MEYLE No. 016 010 6331/HD
Reference No. 211 330 03 35

Ball joint

Mercedes W/S202, W/S210, W/S211 (4-matic), W220, R170, A/C208

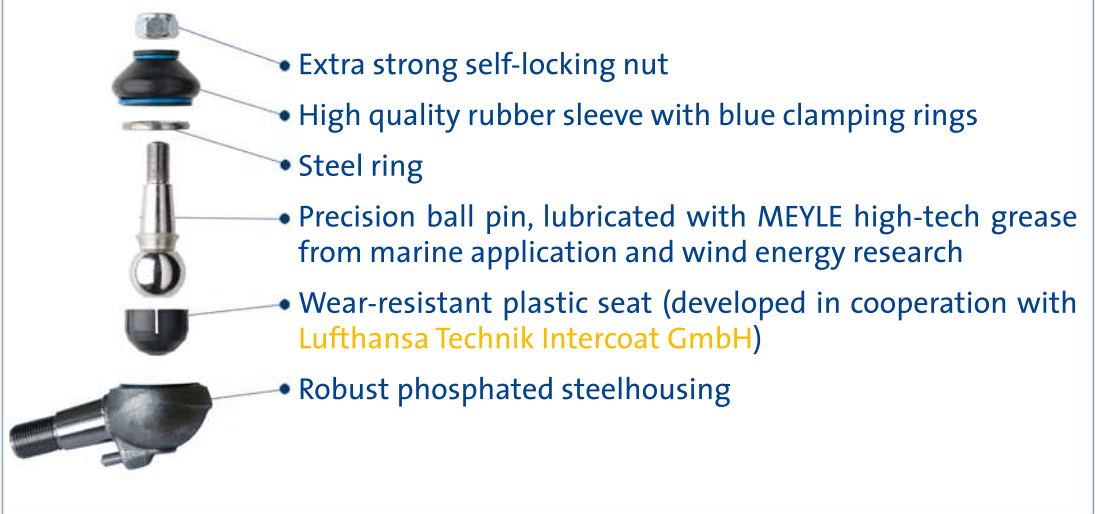
- High dynamic strain on ball joints
- Premature wear

- Worn joints
- Noise from the front end
- Impaired driving safety

- Use of extremely long-wearing plastic ball joint sockets (designed in cooperation with **Lufthansa Technik Intercoat GmbH**)
- MEYLE high-tech grease
